Formal Submission of Further Information

Re: Request for Further information
Planning Application reg ref : SD21A/284
Decision Order No PR/1596/21/21

RE: Planning application by Oceanglade Ltd for development on site of 0.72 hectares at Liffey Valley, Dublin 22, to the south of the N4, to the west of the existing Johnson and Johnson office building, to the north and east of Giraffe childcare and to the north of Liffey Valley secondary estate road.

Folio Number DN125564F
 Title Level Freehold
 Plan Number 2RTR
 Property Number 1
 Area of selected plans 2.38 hectares
 Number of Plans on this folio: 2
 Address Not Available

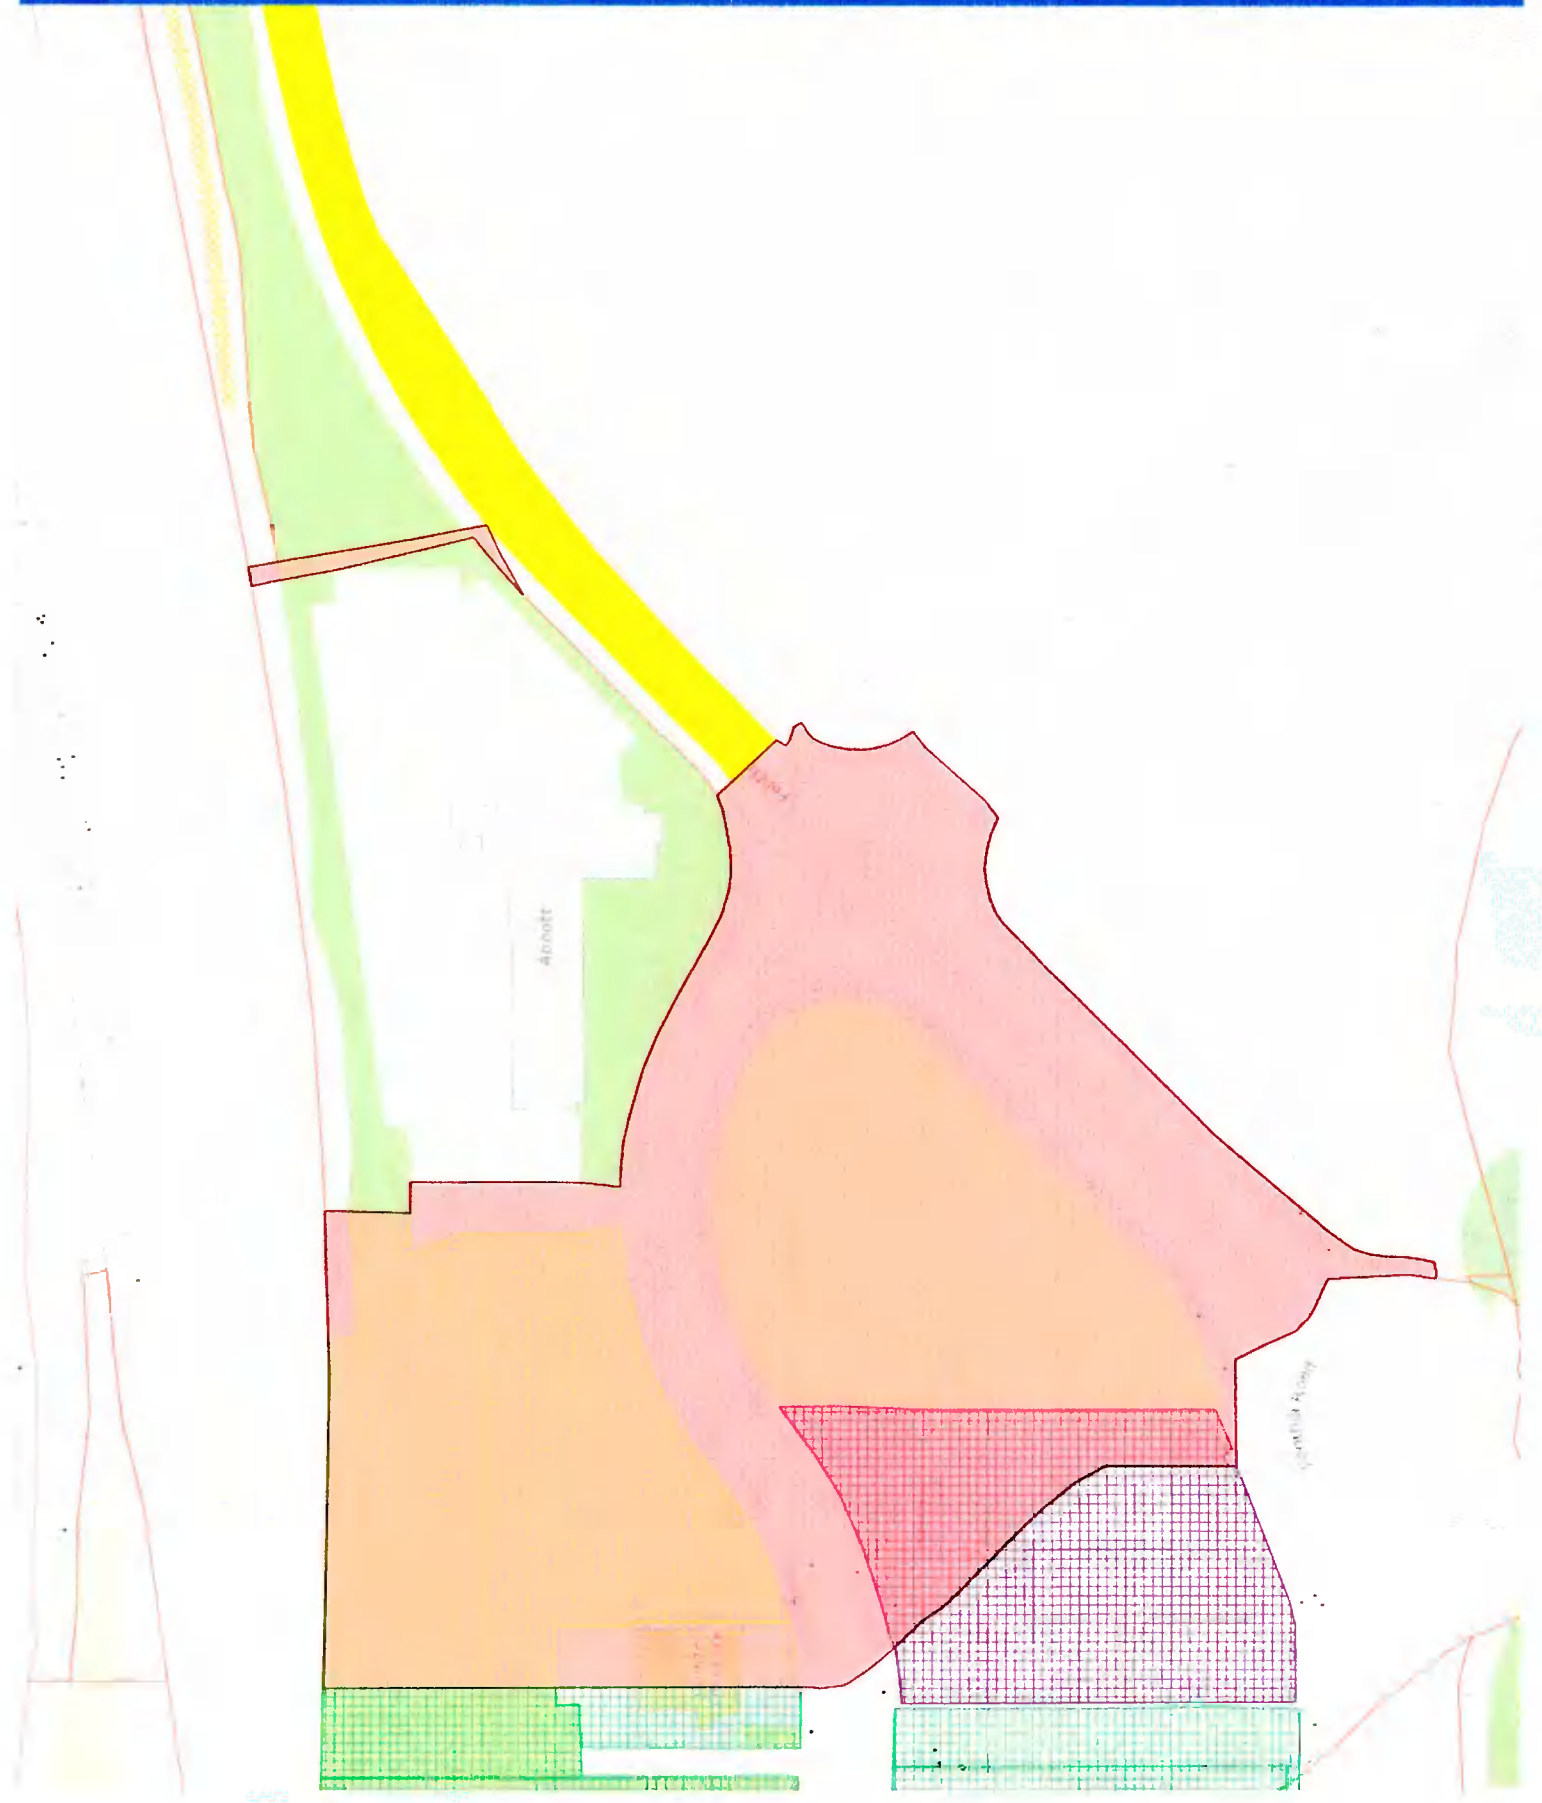
(2) Eastern Access - The proposal includes an access to the east via an existing internal access road on the neighbouring site to the east. Again, there are concerns in regard to control over this access and traffic safety. The applicant is requested to submit evidence that they have legal right to utilise this access. This might be in the form of a written letter, detail of any right of way(s) and/or drawings. A revised layout plan showing a two-way (access/exit) design through this shared access which shows traffic priority and proposed road line markings is requested and should form part of the response to this item of Additional Information.

In summary, the applicant has full rights of way over the eastern access road, please refer to the map accompanying folio125564F , extract enclosed along with e-mail from Rennick & Co.
